ADDENDUM

PROJECT: Forestside Estates
Attmar & Palleschi Drive
Brampton, Ontario

ADDENDUM NO. M-2

PURPOSE: To match Architectural changes and coordination as discussed on coordination meeting.

DRAWN MC	CHECKED LM	SCALE 1:200
DATE MAY, 2019	PROJECT 18-017	DRAWING M-1
		OF

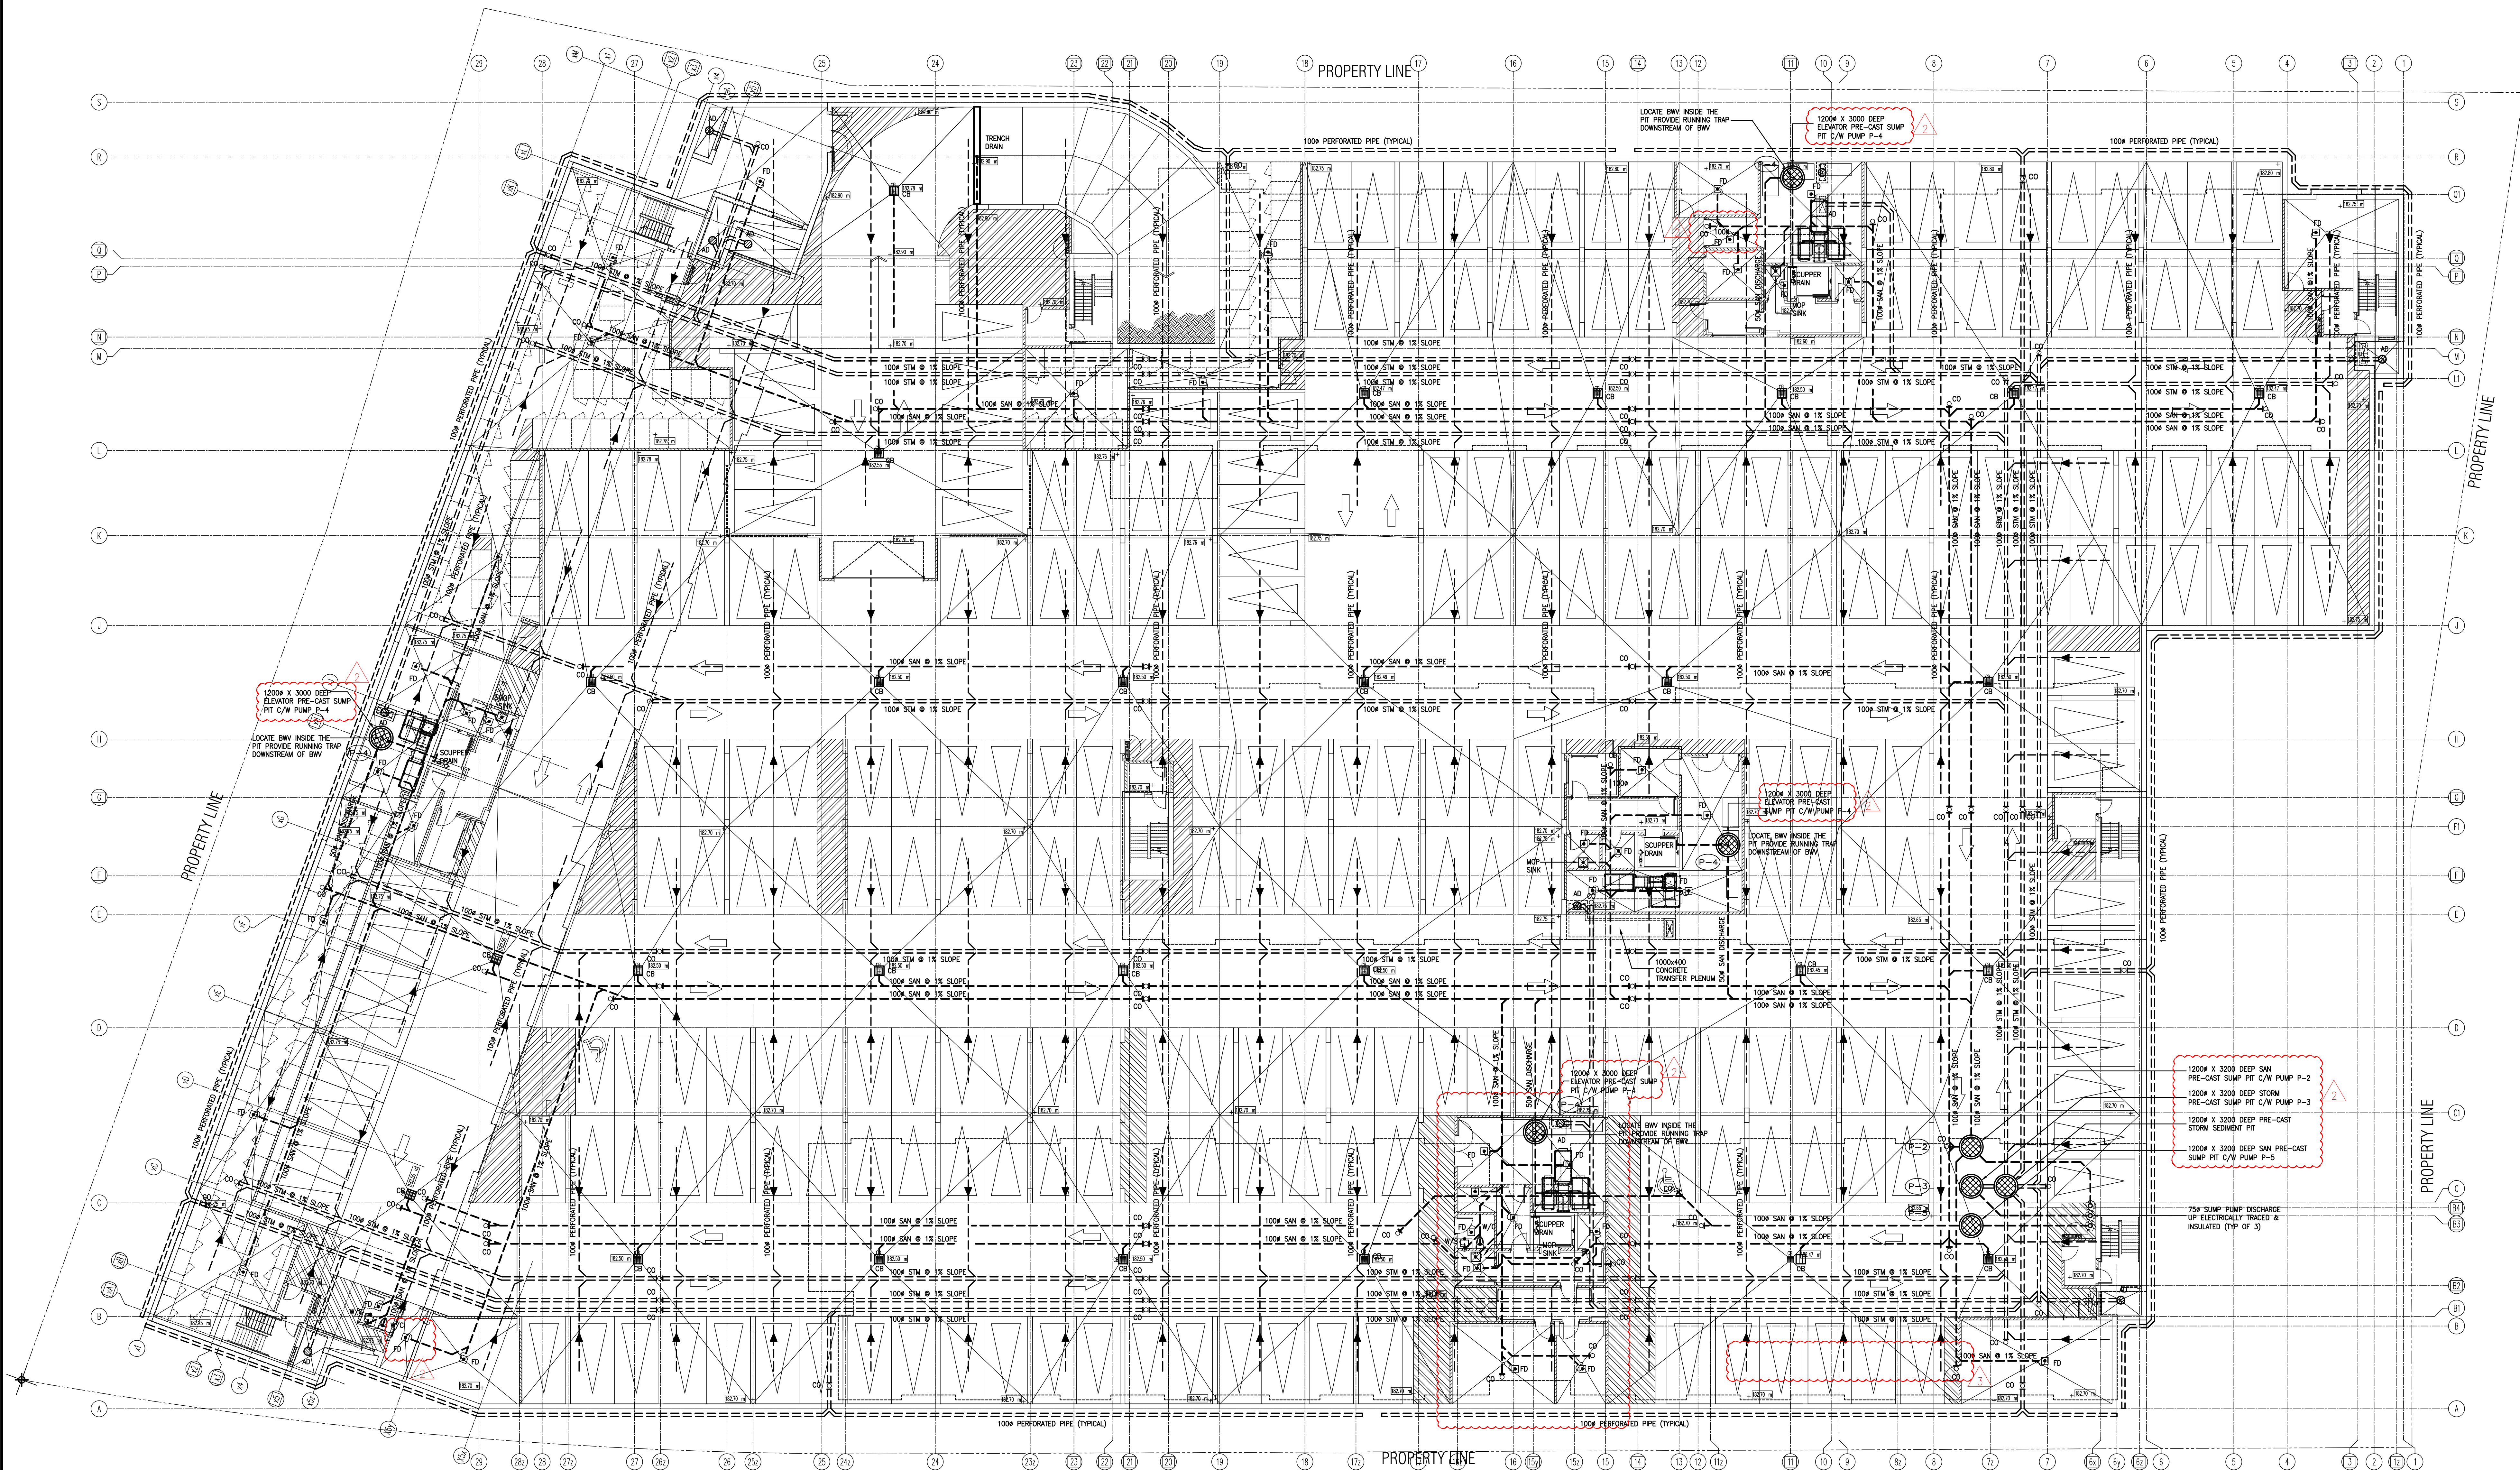
1.0 Mechanical drawing M-1 (Site Plan - Mechanical) Issued

1.1 Relocated: Exhaust shaft.

DRAWN MC	CHECKED LM	SCALE 1:100
DATE MAY, 2019	PROJECT 18-017	DRAWING M-2B
		OF

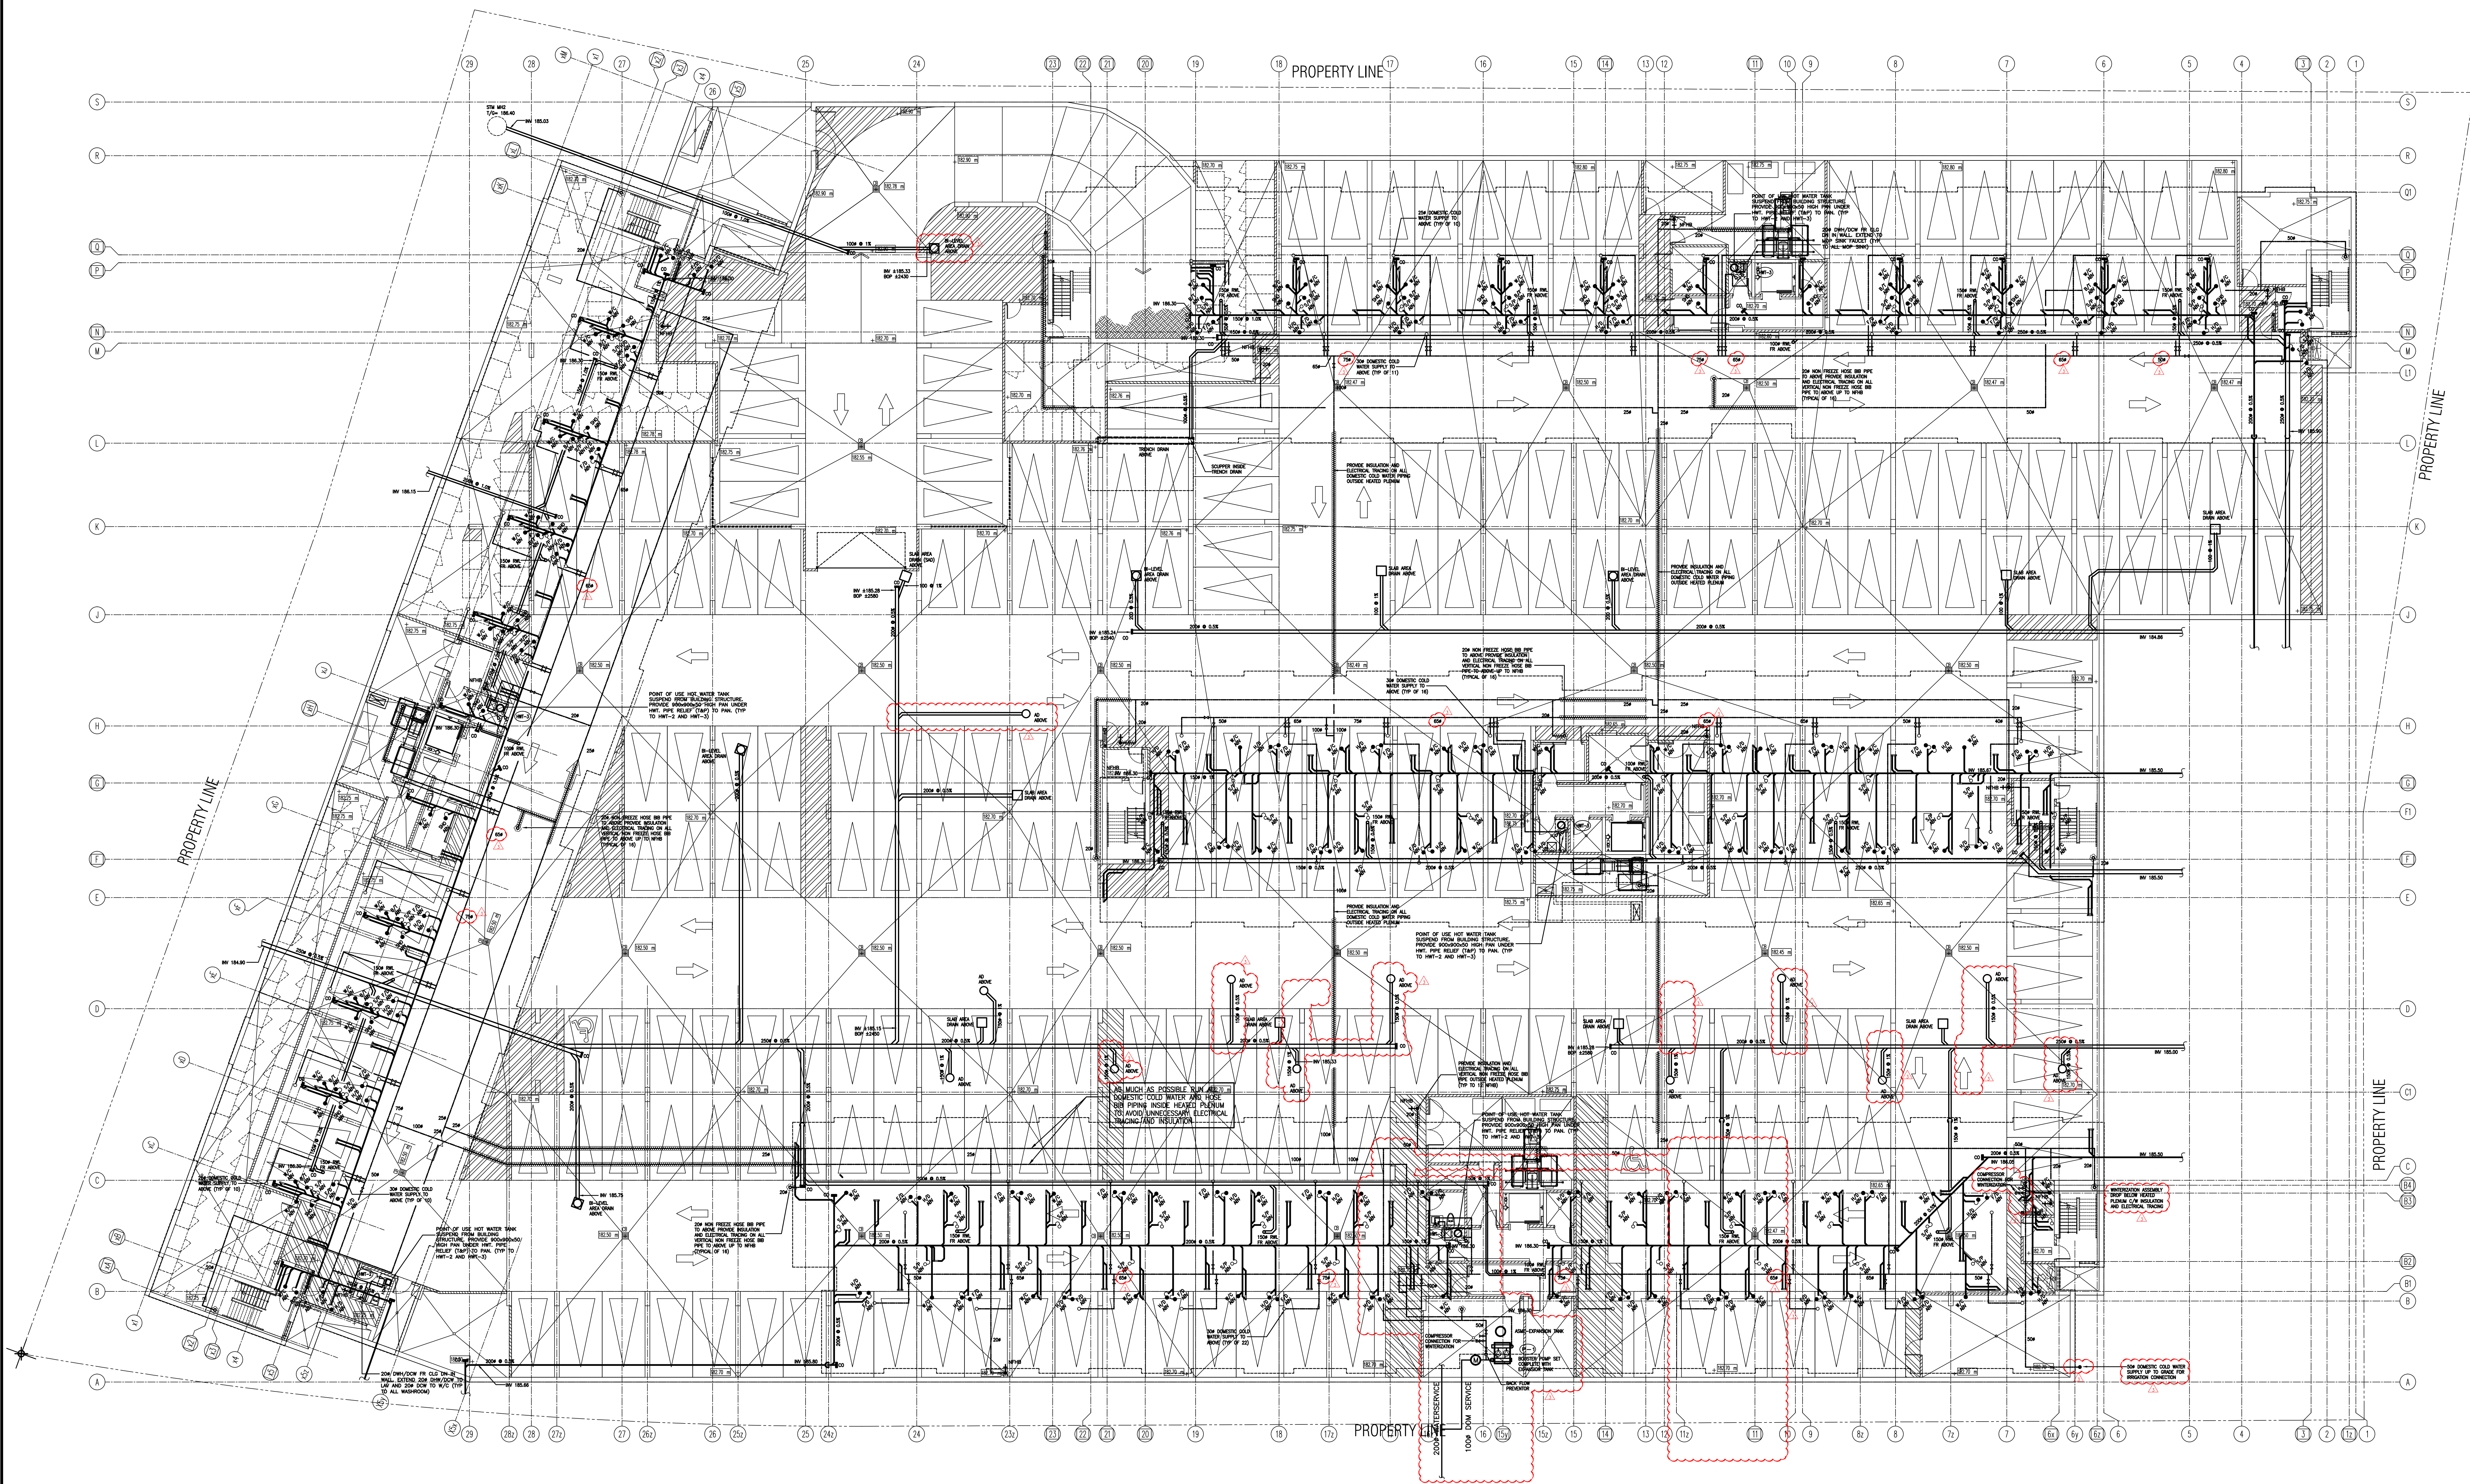
4.0 Mechanical drawing M-2B (Underground Drainage Layout – Mechanical-Part 2) Issued

4.1 Revised: Area drain locations & corresponding storm piping connection.

DATE	PROJECT	DRAWING
MAY, 2019	18-017	M-3B

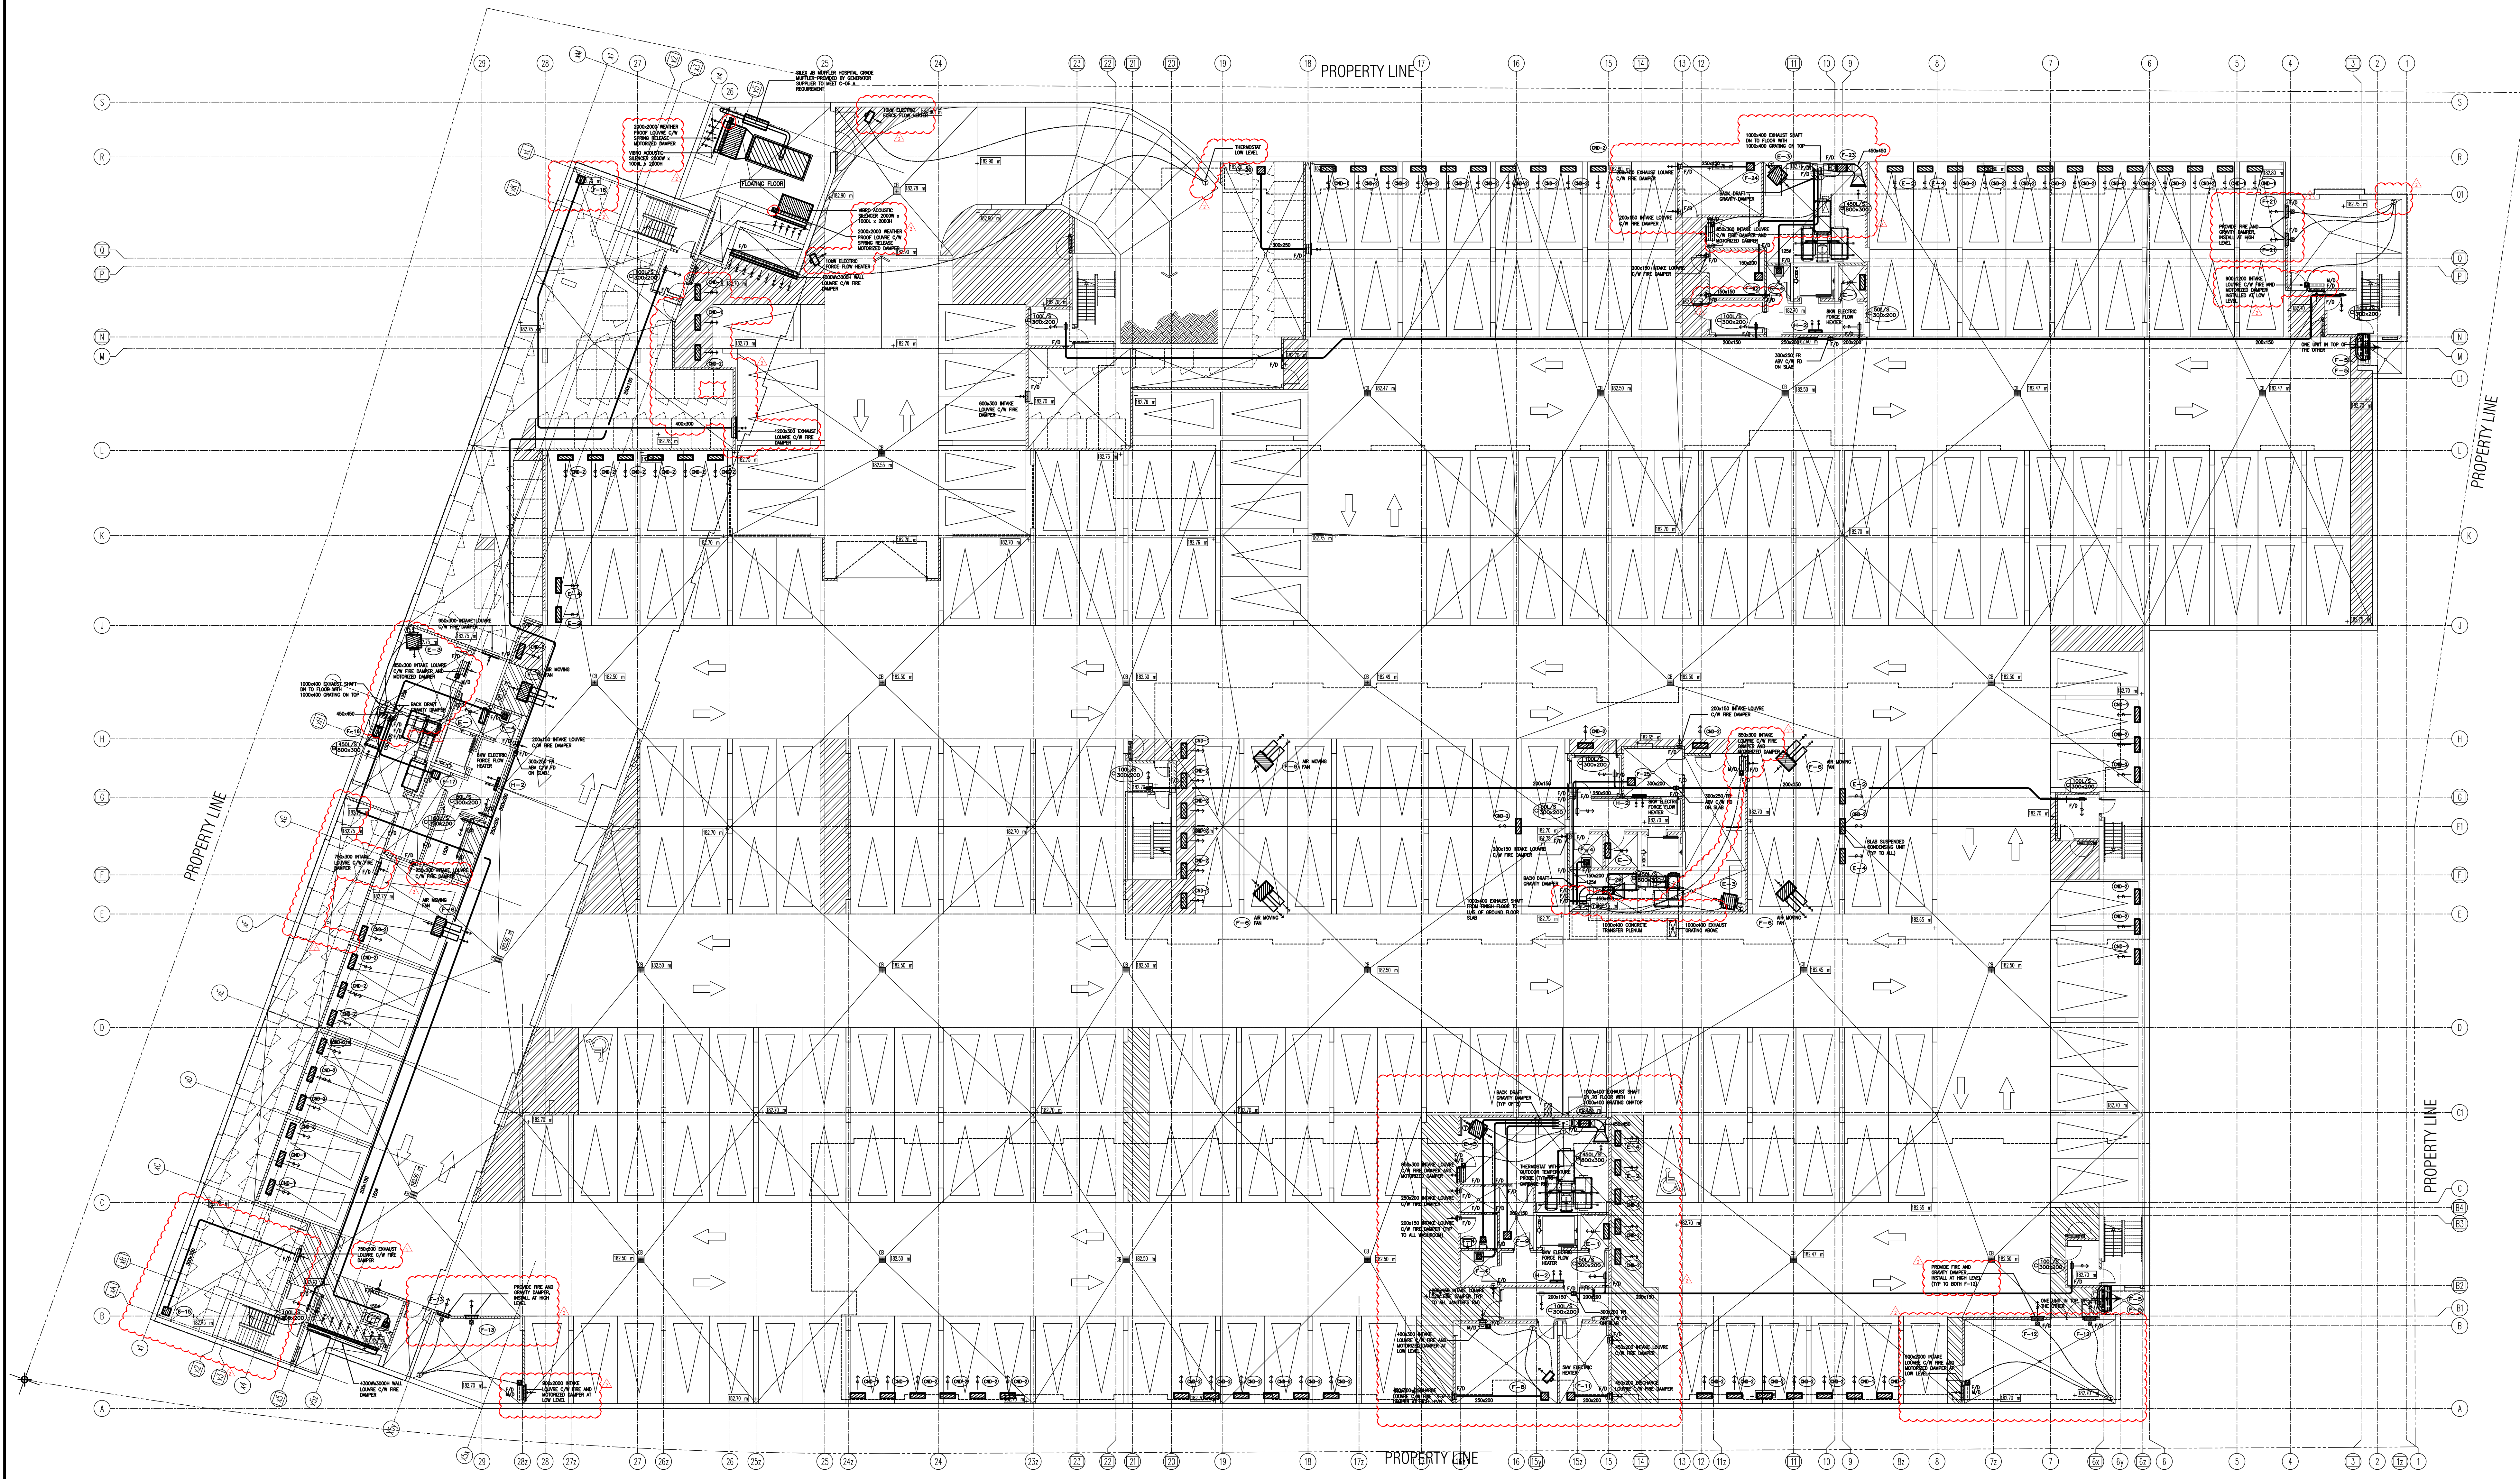
7.0 Mechanical drawing M-3B (Parking Level - Plumbing – Mechanical-Part 2) Issued

7.1 Revised: Area drain locations & corresponding storm piping connection.

7.2 Added: Winterization assembly to DCW system c/w compressor connection.

7.3 Revised: Domestic Cold Water and Hose bib piping layout.

REVISIONS	
NO.	DESCRIPTION
1	AS MUCH AS POSSIBLE RUN 1/2" DOMESTIC COLD WATER AND HOSE BIB PIPING INSIDE HEATED PLENUM TO AVOID UNNECESSARY ELECTRICAL TRACING AND INSULATION
2	WINTERIZATION ASSEMBLY DROP BELOW HEATED PLENUM C/W INSULATION AND ELECTRICAL TRACING
3	30" DOMESTIC COLD WATER SUPPLY UP TO GRADE FOR IRRIGATION CONNECTION
